GENERAL APPLICATION

Location Address: 1604 Cleveland St. Hollywood, FL 33020

The following are the responses to your plans review comments of the above mentioned project:

NEW TOWNHOUSE FOR:
CLEVELAND HOMES LLC.
1604-1606 CLEVELAND ST.
HOLLYWOOD, FL 33020

1 TYPICAL UNIT A FIRST FLOOR PLAN
1/4" = 1'-0"

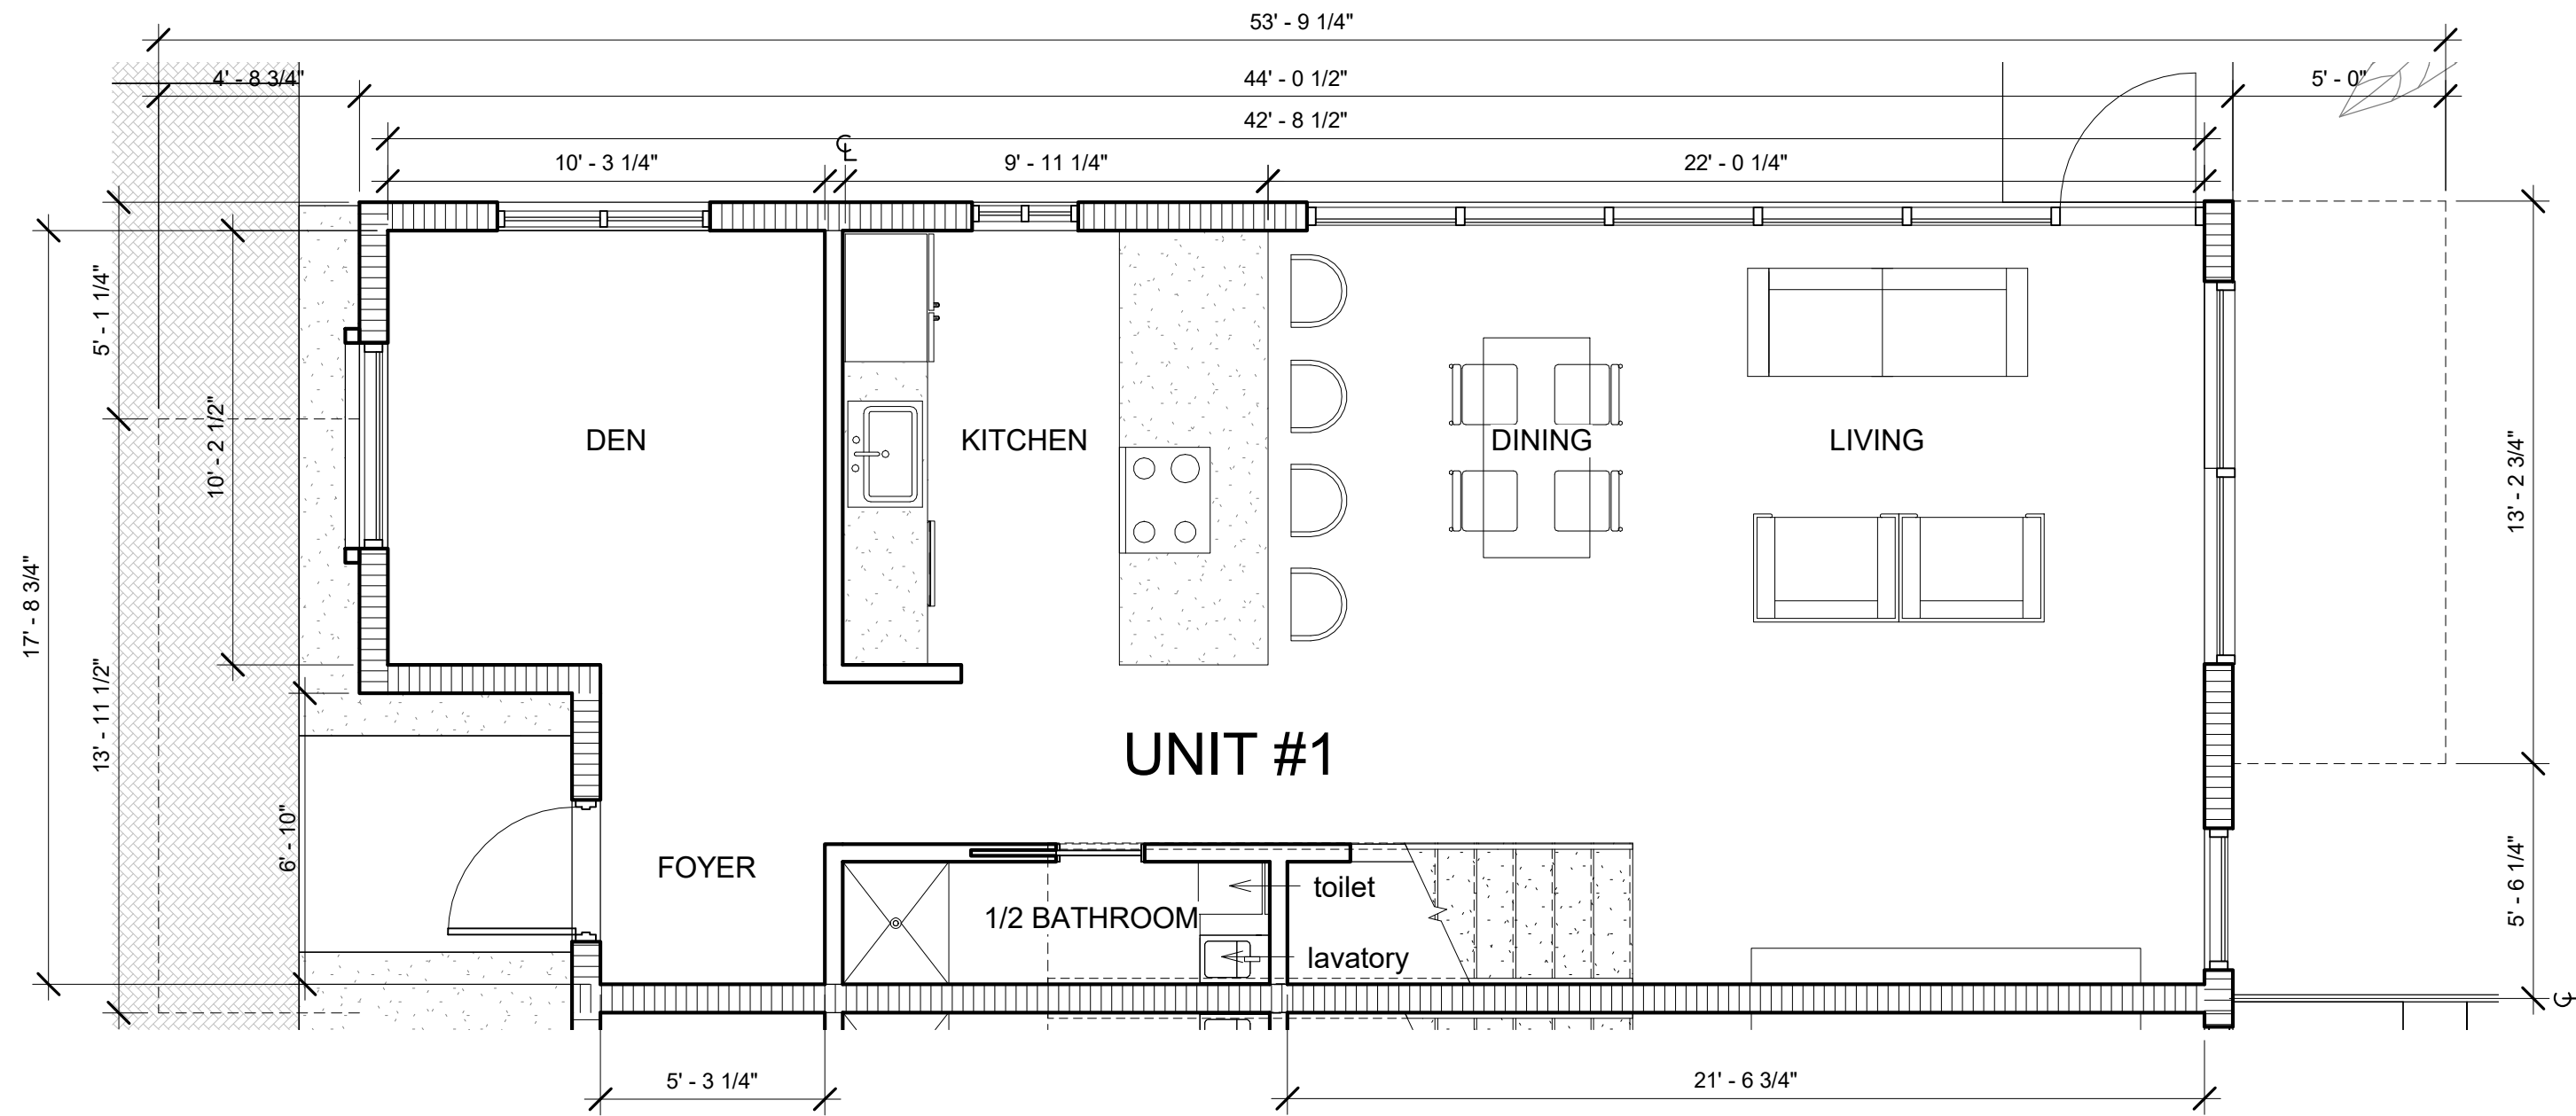
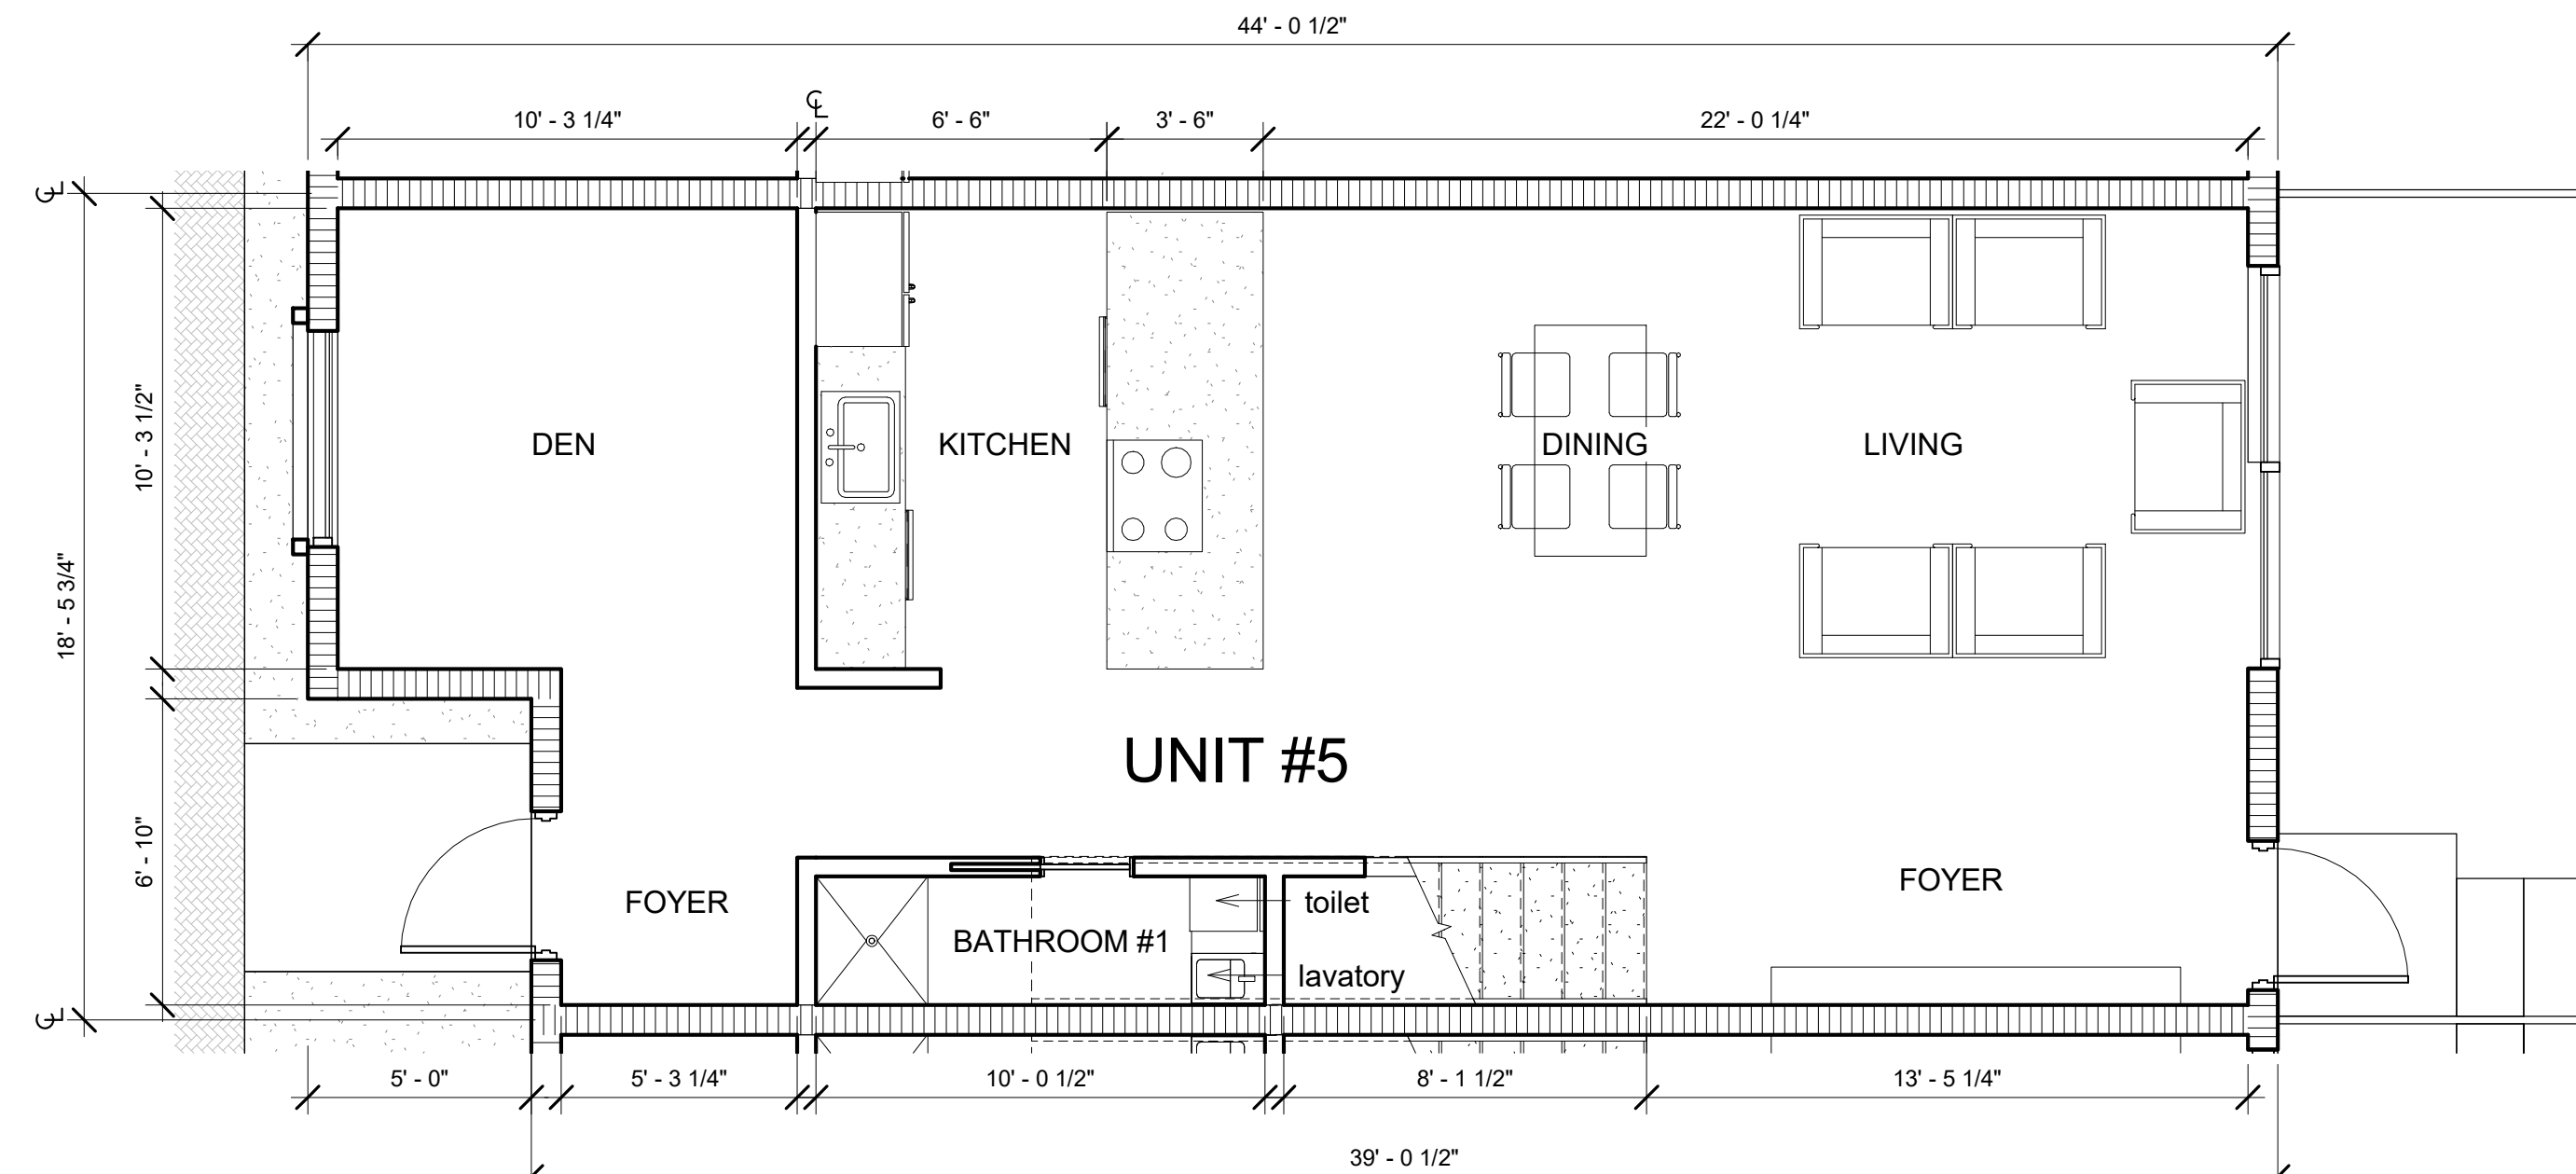
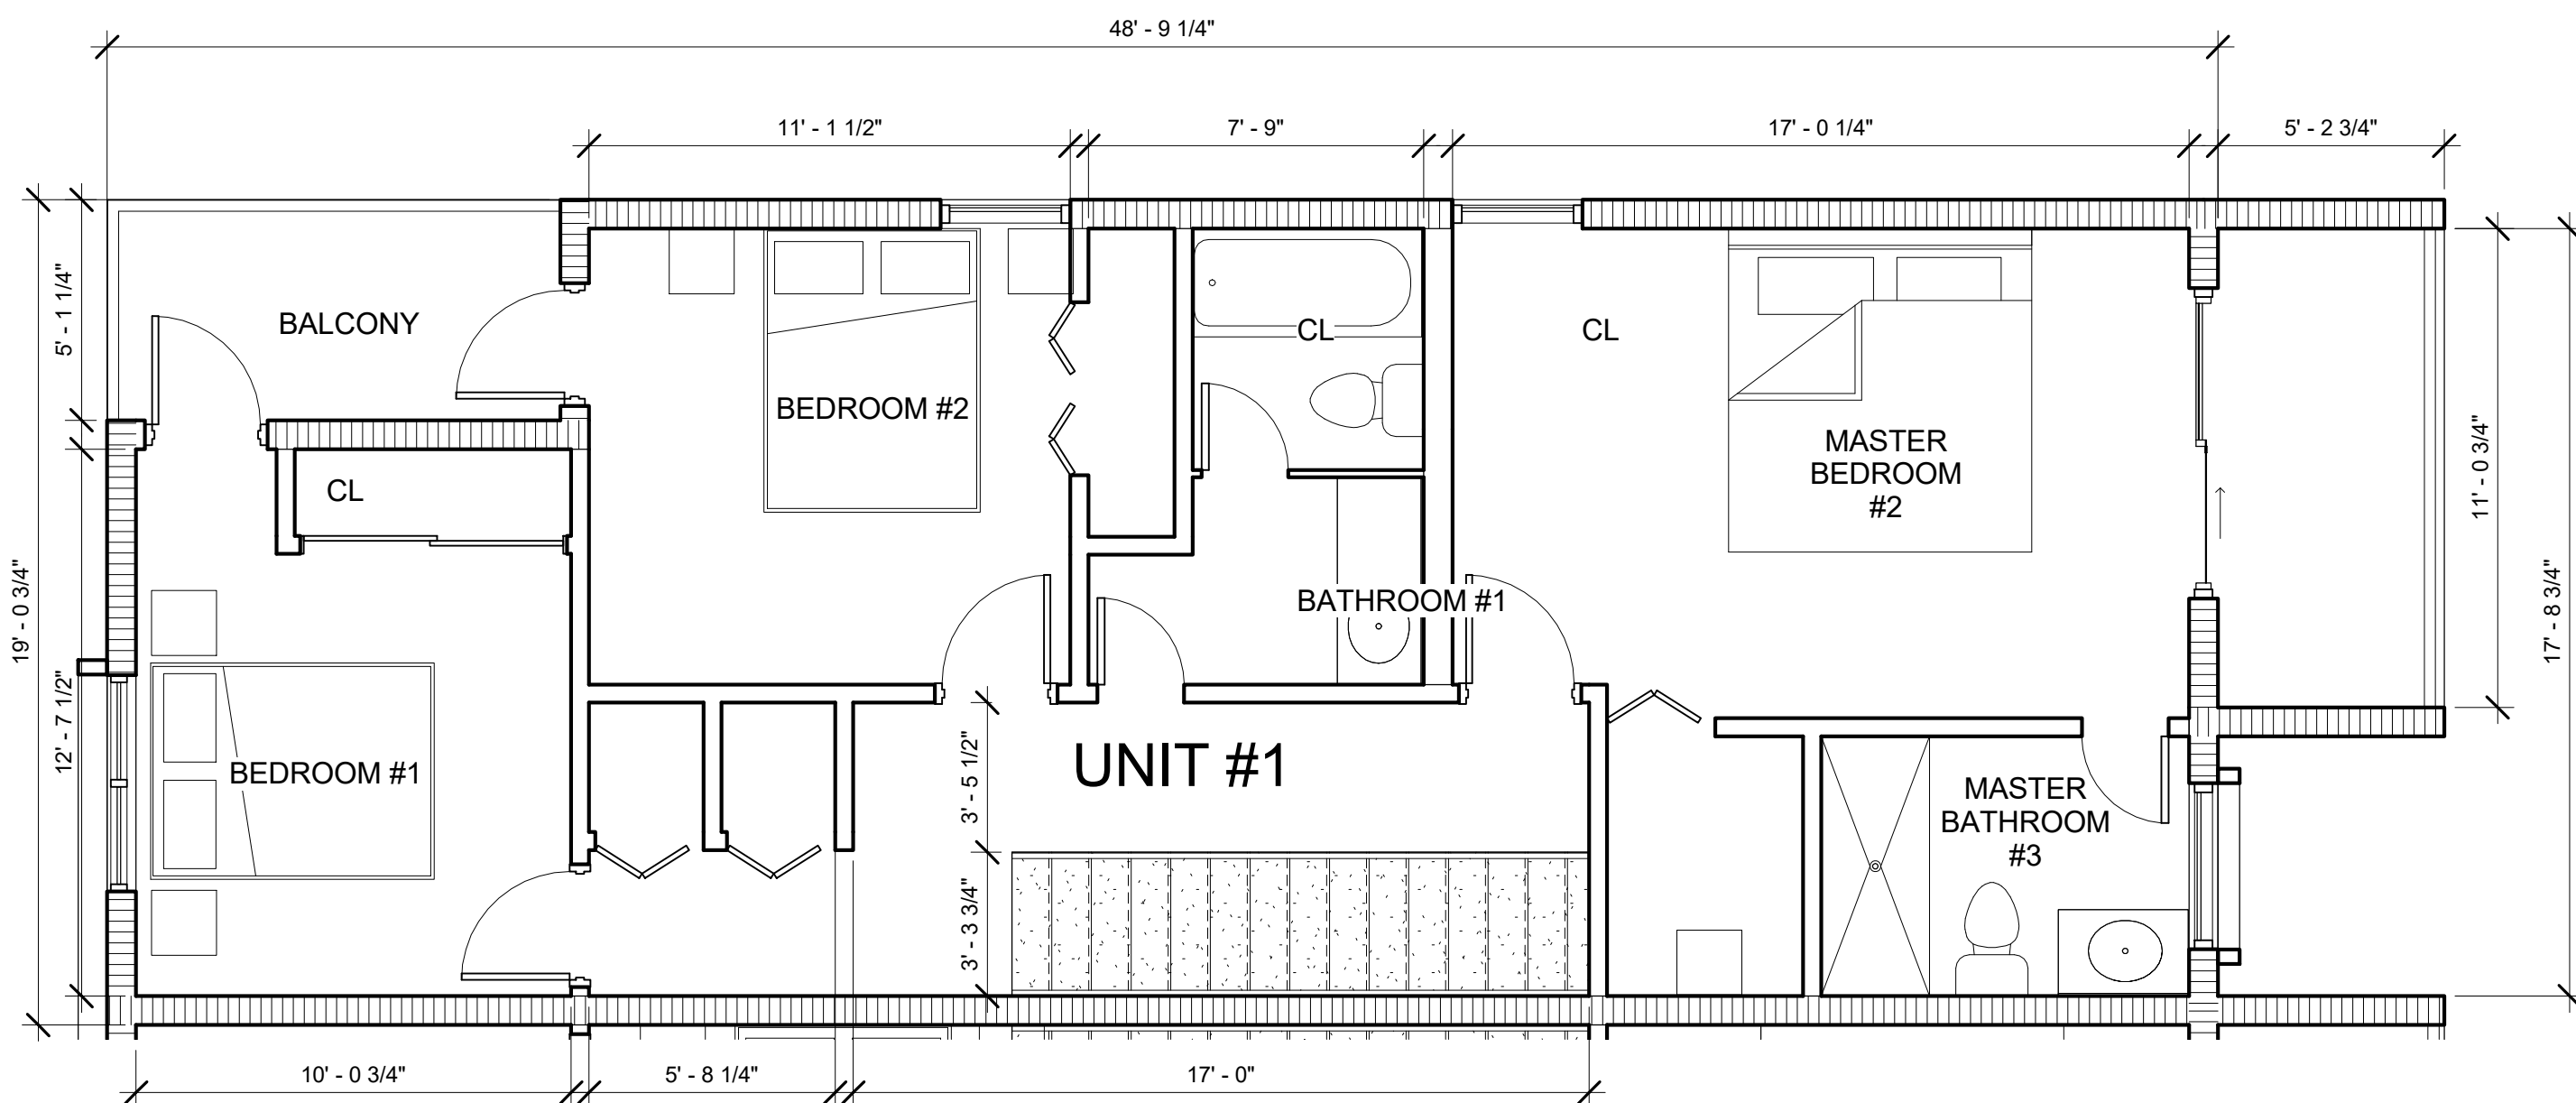
5. Sheet A6.0:

- a. Dishwashers appear to be located in the kitchen island. Consider relocating d/w adjacent to sink
- b. Master bedroom and master bathroom labels are reversed in Unit #1.
- c. Show details of master bathroom in Unit #5.

R: See revised floor plans. (REMIND MIGUEL)
